MEETING AGENDA
CITY PLAN COMMISSION
Wednesday, January 25, 2023
Work Session 12:30 p.m.
Public Hearing: 1:30 p.m.

1. **PP-21-009 Ventana Phases 6-8 (Revision/Waiver Request): 538 Single-Family Detached Residential Lots and 16 Private Open Space Lots. Council District 3.**

2. **PP-22-039 Lone Star at Liberty Trails, (Waiver Request): 1,603 Single-Family Detached Residential Lots, 1 Amenity Center Lot and 40 Private Open Space Lots. ETJ-Denton County.**

PRELIMINARY PLAT
FOR
VENTANA PHASES 6-8

PP-21-009

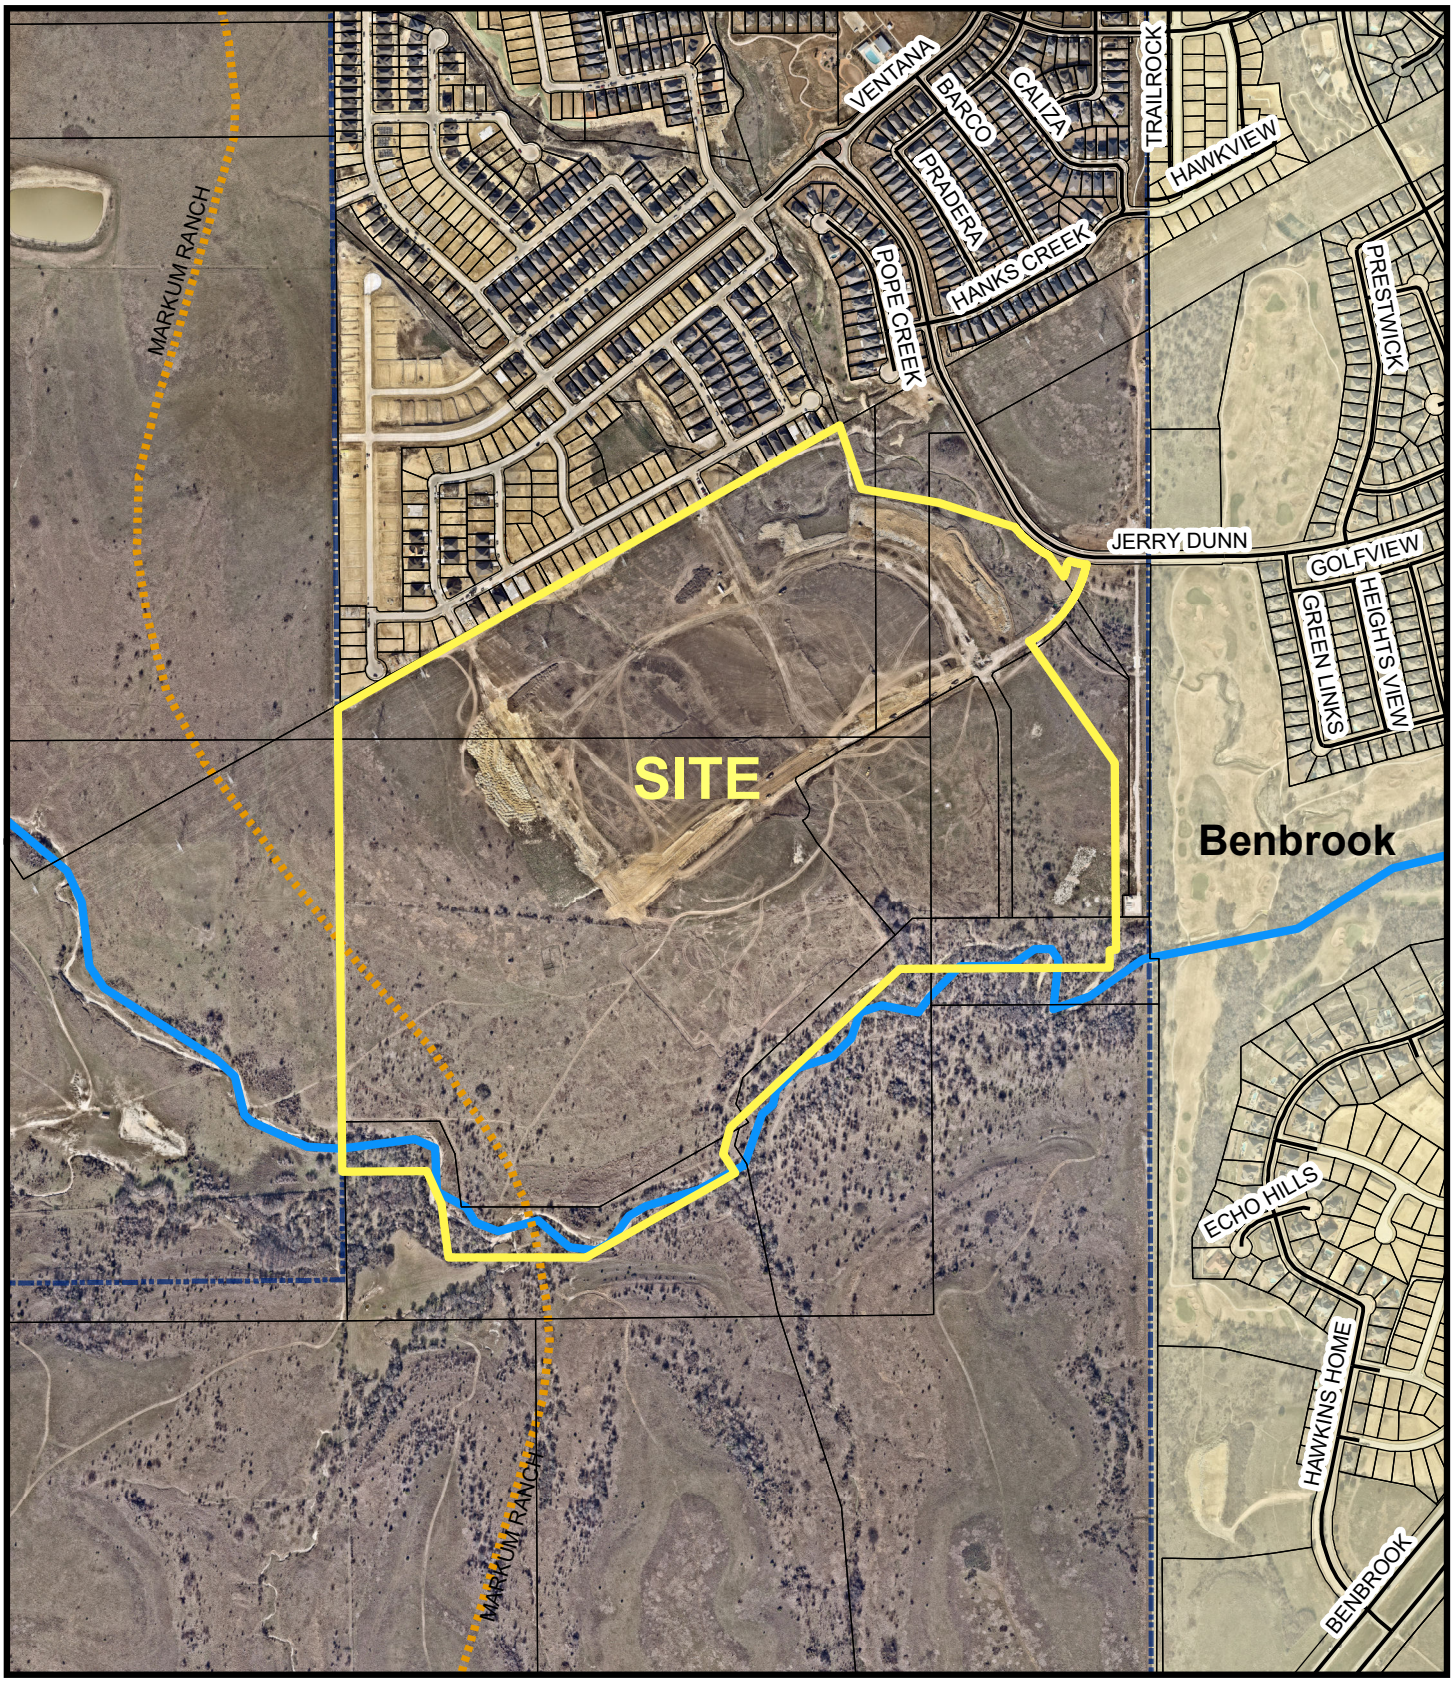
The Ventana Preliminary Plat Phases 6-8 was originally approved administratively in May of 2021. A revision to the Preliminary Plat was submitted containing the following changes: the cul-de-sac orientation between block 5 and 6, orientation of blocks 13 and 14 and the orientation of the cul-de-sac between blocks 15 and 11. Due to the orientation change of blocks 13 and 14, from east and west to north to south, a site visibility issue was introduced at the southern portion of block 17. City staff met with consultant and determined that removing the most southern lots from block 17 to block 15 and to carry out Street R would eliminate the site visibility issue. However, when carrying out Street R, a long block was created. The Subdivision Ordinance in Section 31-106 (20) (2) states, standard public and private local streets that serve large lots, 150 feet in width or greater, shall have a maximum block face of 1,950 feet. Block 15, Lots 1-46, has a block length of 2,300 feet. The applicant states that due to the floodplain located to the south of the development, a stubout to break the long block is not possible.

The proposed preliminary plat will require a waiver for stubouts. Subdivision Ordinance, Section 31-106(c)(7)(a) requires that local streets shall be extended to the subdivision boundary to connect with adjoining streets or with adjoining unplatted property. The unplatted tract to the south and west are unplatted. A project redesign or CPC waiver requests is required. CLEARED 3/9/21 DSC. REVISED PRELIMINARY PLAT.

- 1. Provide a description of what all of the changes are. Block 5 bubbled near lots 21 and 22 but not seeing the change.
  2. Is lot 1X Block 11 part of the original PP boundary?
  3. Cul-de-sac change near Block 11, changed in orientation. Might have to go to CPC due to perimeter street change.
  4. Will discuss at DRC

2. The Floodplain Easement called out per SWM-2020-0015 doesn't match the current proposed Ultimate Floodplain Boundary and Easement per DS-21-0116 Revised A11 Cross Section & A12 Phasing Map.

Please revise the lot layout to show subdivision residential lots outside of the Floodplain Easement.
{City of Fort Worth Subdivision Ordinance Article 6, Sec. 31-105 (c)(1)}
LOTS PULLED OUT OF FLOODPLAIN EASEMENT - CLEARED - RNS - 1/6/23

DRC supports the waiver request and the revision to the preliminary plat.

DRC recommends: 1) Approval of one Subdivision Ordinance waiver to allow one block face (Block 15, Lots 1-46) to exceed the maximum length of 1,320 feet, and: 2) Conditional approval of the preliminary plat upon meeting the platting comments in the staff report.

KEY MAP
NOT-TO-SCALE

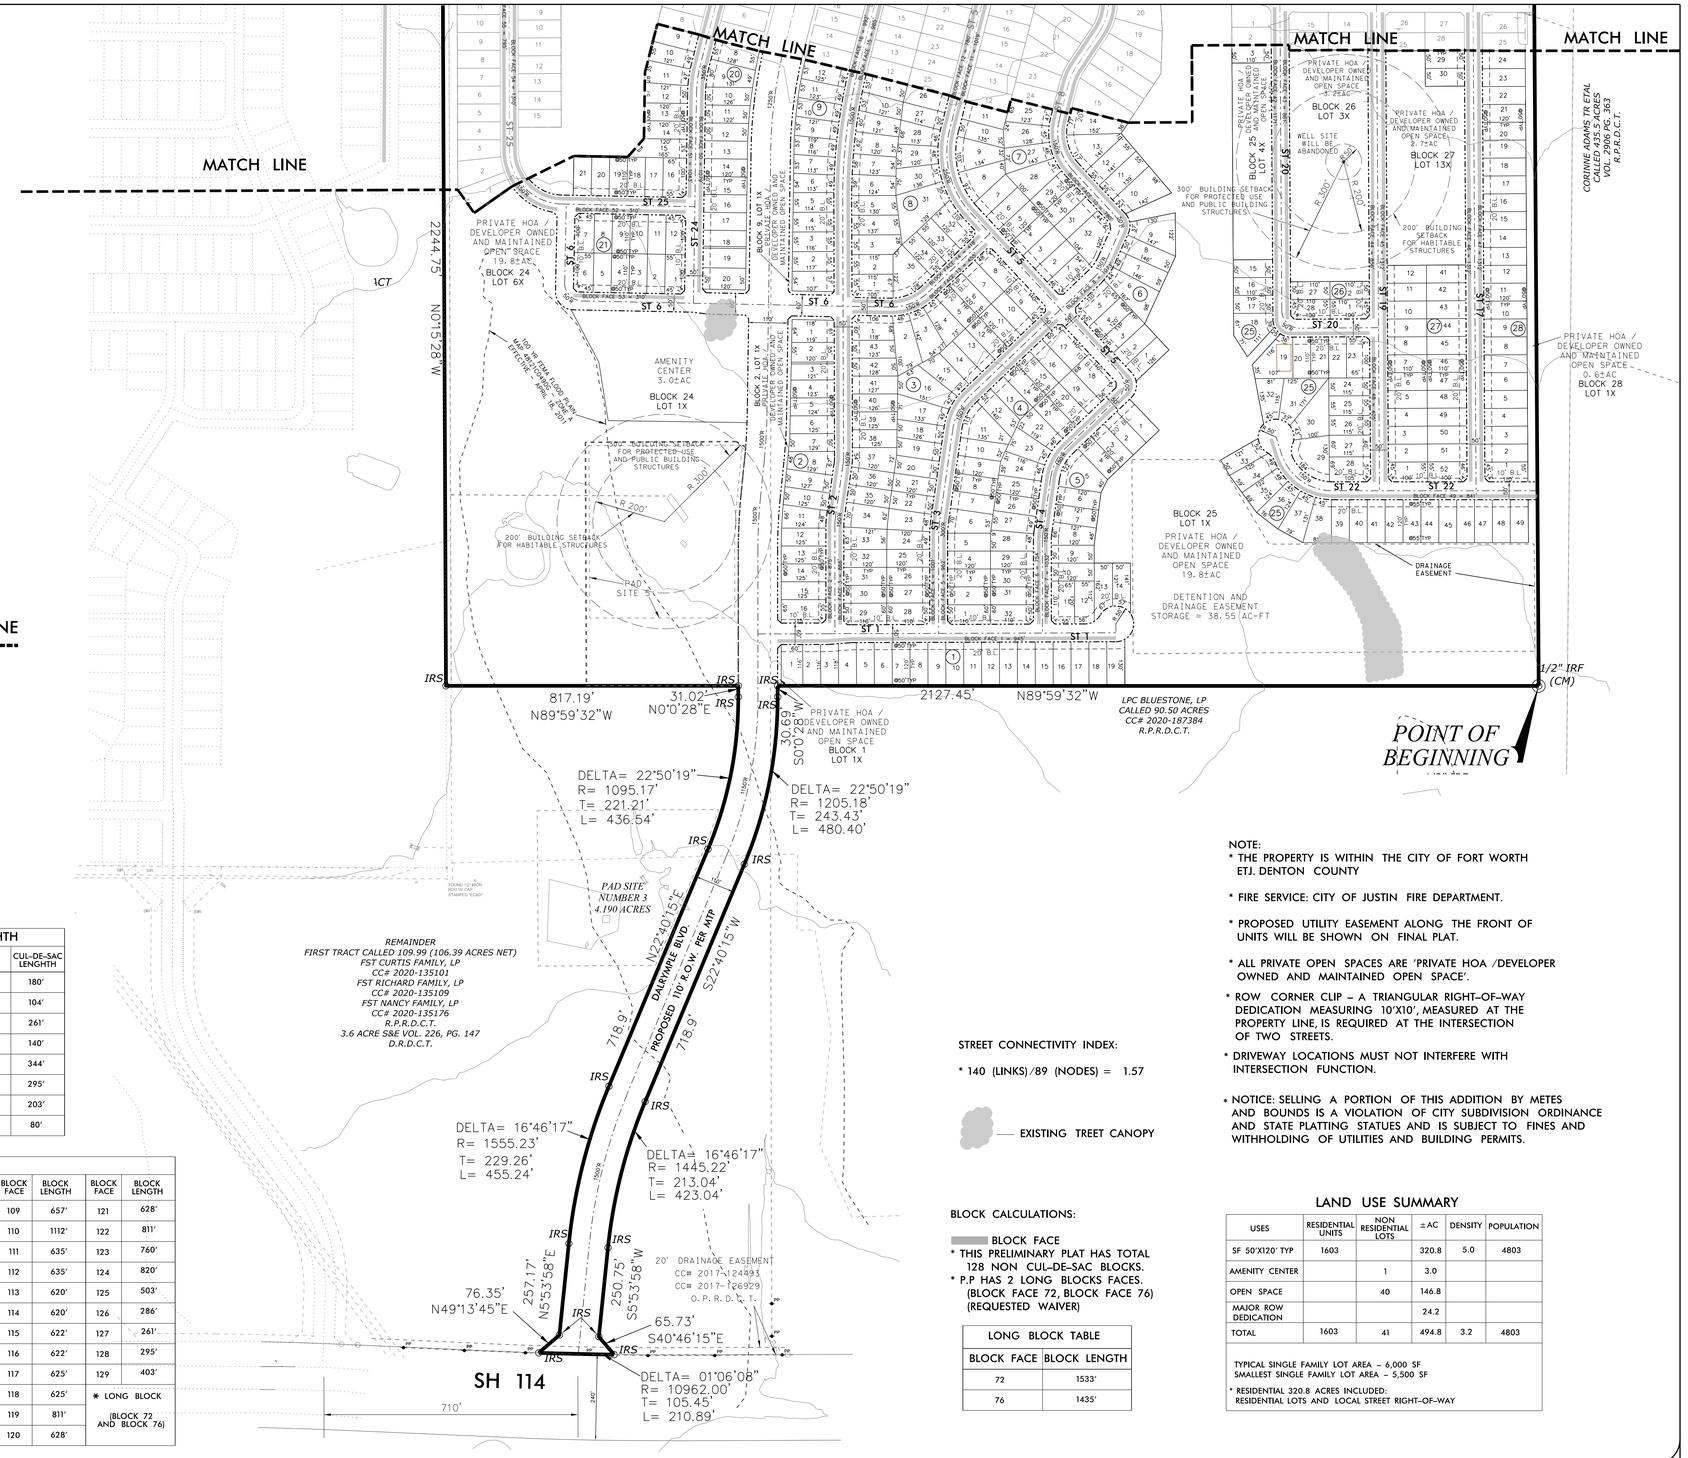
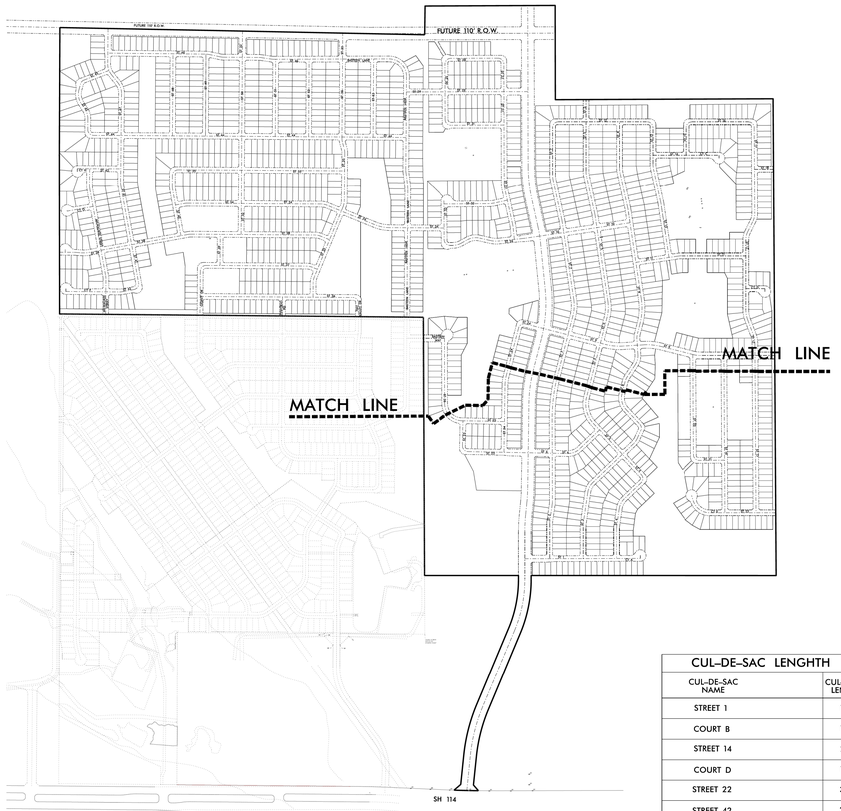
CLEARED 1/12/2023 DH: CORRECTIONS REQUIRED: Change Basteen Lane to Friesland Lane as a continuation from FP-22-093.
CLEARED 1/12/2023 DH: CORRECTIONS REQUIRED: Make Street 7 and Street 2 the same.
CLEARED 1/1/2023 DH: CORRECTION REQUIRED: Label north/south MTP from SH 114 as Dalrymple Blvd.
CLEARED 1/3/2023 DH: CORRECTION REQUIRED: Phasing plan shows two Phase 2 sections. Clarify phasing.
CLEARED 1/3/2023 DH: Change Basteen Way to Montello Lane as a continuation from FP-22-093.
CLEARED 1/3/2023 DH: Change Peshtigo Road to Amberg Drive as a continuation from FP-22-093.
CLEARED 1/3/2023 DH: Make Street 47 and Street 41 the same street name.
CLEARED 1/3/2023 DH: Make Street 42 and CT F the same street name.
CLEARED 1/3/2023 DH: Make Street 43 and CT H the same street name.
CLEARED 1/3/2023 DH: Make Street 26 and Street 10 the same street name.
CLEARED 1/3/2023 DH: Make Street 14 and CT C the same street name.

CLEARED 1/12/2023 DH: CORRECTION REQUIRED: Show well head setbacks for padsite near Block 73 Lot 1X on north side.

2. (Cleared per email on 1-10-23)Each phase of the development shall have 2 points of ingress/egress to a public street.
  3. (Cleared 1-4-23)Stub-outs to adjoining un-platted tracts and street extension and continuation from adjoining developments. Urban local streets shall be extended to the subdivision boundary to connect with adjoining streets or where no adjacent streets are available for such connection with adjoining un-platted property, subject property to the west [S.O. Sec. 31-106(c) A redesign or a waiver will be required from the City Plan Commission.

7. (Cleared 1-20-23)Provide the long block table on the preliminary plat not phasing plan, please update accordingly. The block table indicates 76, the block information on the plat stops at 73.

DRC recommends: 1) Approval of one Subdivision Ordinance waiver to permit two block faces lengths, Block 72 (Basteen Lane), and Block 76 (Geskey Drive) extended from existing Lone Star subdivision from the south into the preliminary plat, to exceed the maximum length of 1,320 feet; and 2) Conditional approval of the preliminary plat upon meeting the platting comments in the staff report.
